Re: FortisBC Energy Inc. (FEI)

Project No. 1599152

**Application for a Certificate of Public Convenience and Necessity for the
Okanagan Capacity Upgrade (OCU) Project (Application)**

**Response to the British Columbia Utilities Commission (BCUC) Information
Request (IR) No. 3**

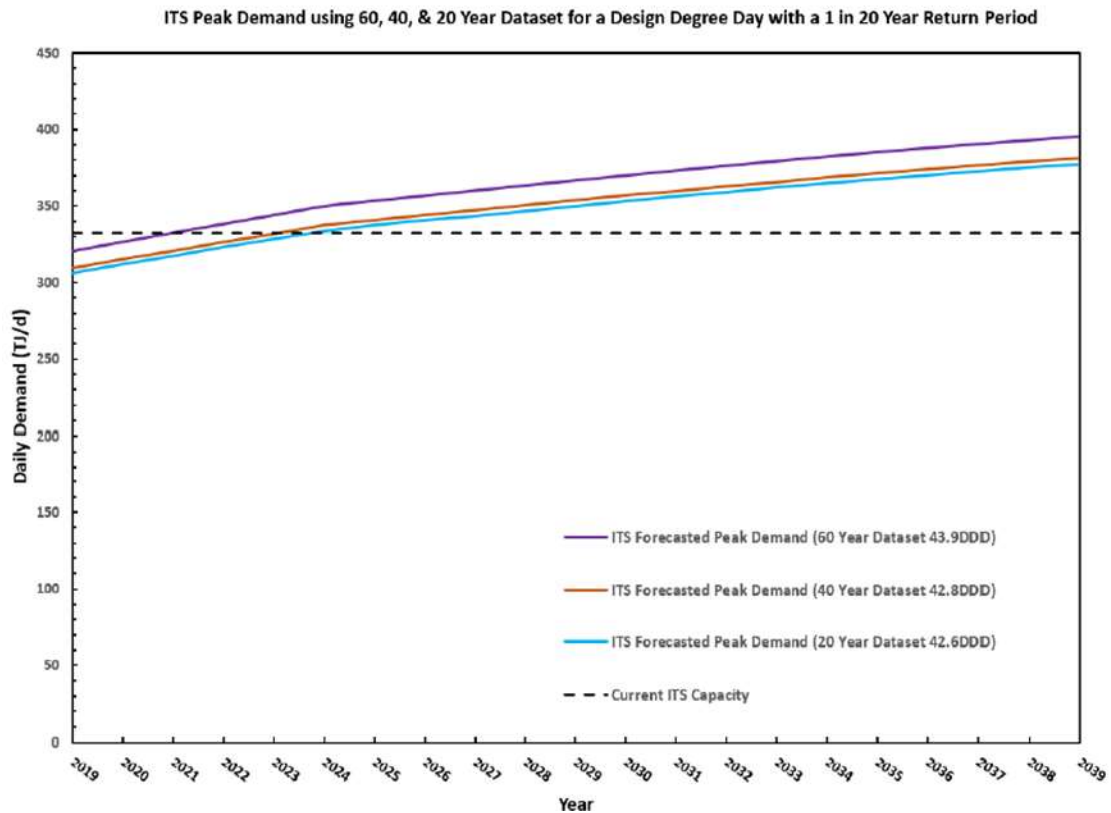
66.1 Please clarify whether in its response to BCUC IR 42.5.1, the line representing “DSM – 100% Res” is intended to represent residential and commercial customers.

66.1.1 If required, please correct the data in the figure and corresponding table to show the scenario with demand savings from commercial customers included.

FEI confirms that “DSM – 100% RES” represents the DSM savings applied fully to the residential UPC_{peak} only and is not applied to commercial customers.

The requested figure and corresponding table for this hypothetical and speculative additional scenario are provided below.

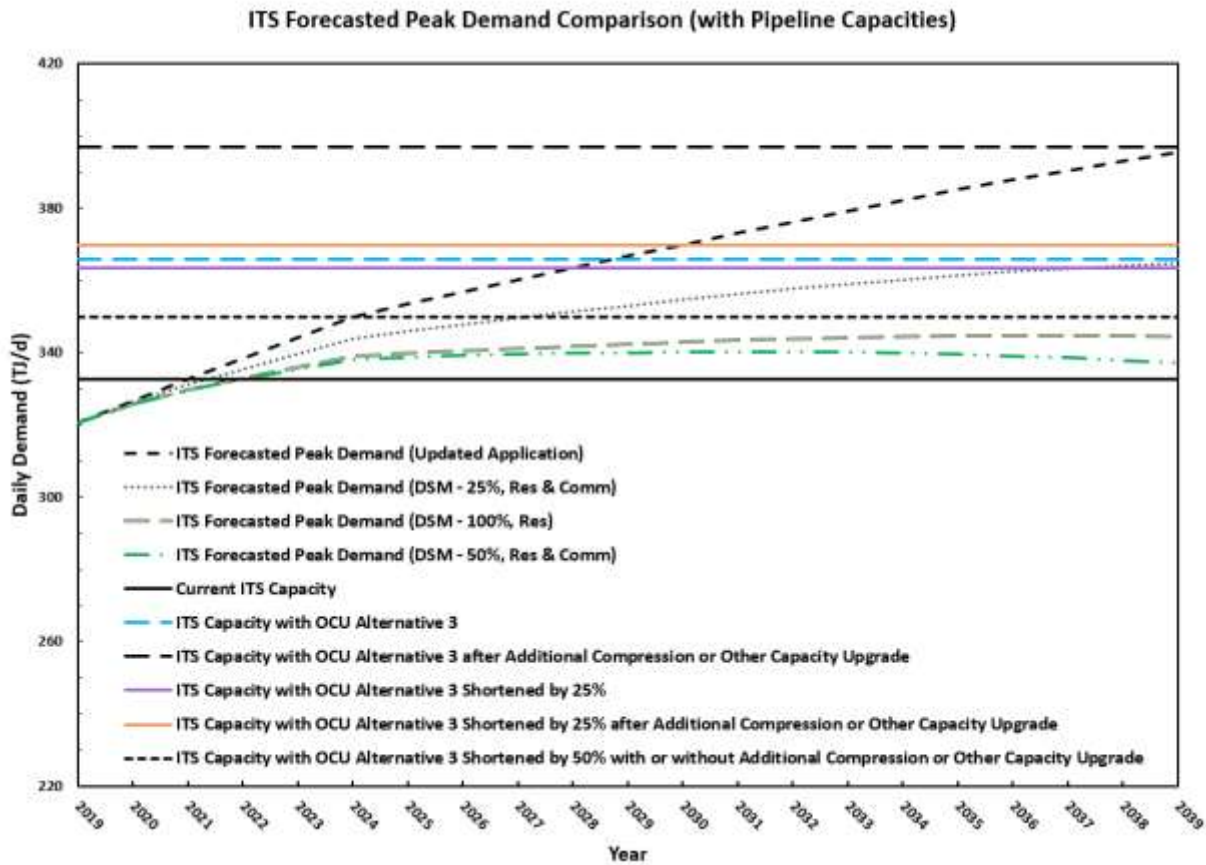
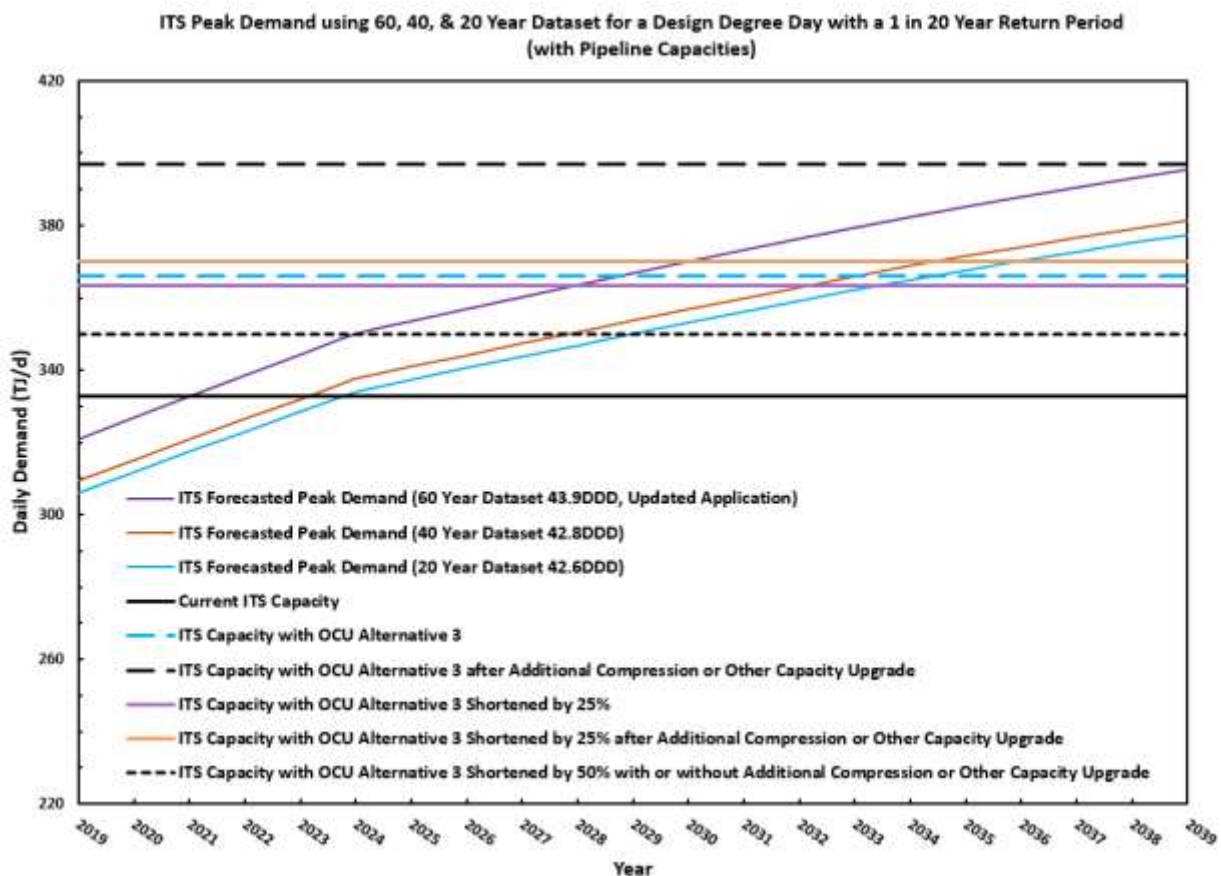
1 66.3 Please provide versions of the figures provided in response to BCUC IR 42.5.1
2 and IR 43.2 overlayed with the capacity of the alternatives outlined in the
3 response to BCUC IR 50.1.

6 The revised figures requested are provided below.

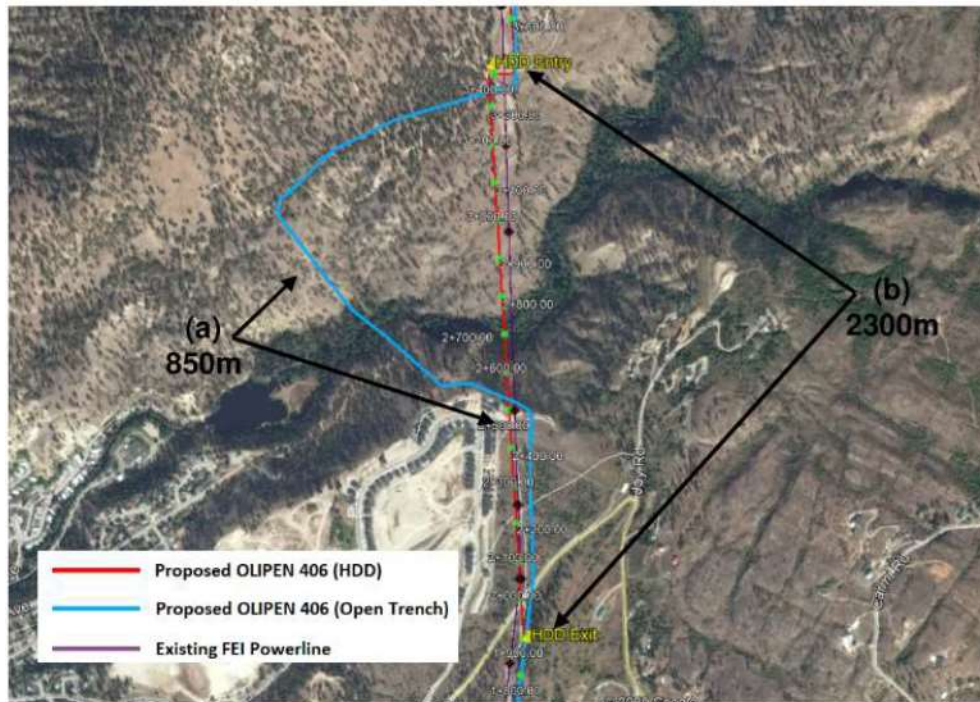
67.1 Please identify the bounds of the Penticton Creek crossing on the map provided in the preamble and explain how these boundaries were determined.

16
17
18
19 67.2 Please discuss whether FEI has identified any potential issues with the proposed
20 route alignments for HDD and open trench crossings that may require a portion
21 of the route alignment to be outside the identified bounds of the Penticton Creek
22 crossing.

The outer bounds of the Penticton Creek crossing are generally as shown in the image, identified in yellow text as the “HDD Entry” to the north and “HDD Exit” to the south as well as

1 between the blue line identified as “Open Trench” to the west and red line identified as “HDD” to
2 the east.

25 FEI has identified one potential issue that is localized near to four homes in the Brent Drive area
26 of Penticton where construction could be challenging due to the close proximity to those homes
27 to the gas line alignment and the steep slopes and terrain. FEI’s project team has identified a
28 civil engineering solution in this location that would stabilize the slopes to allow the alignment to
29 remain within the identified bounds, and is working with geotechnical and construction experts
30 to confirm the solution.
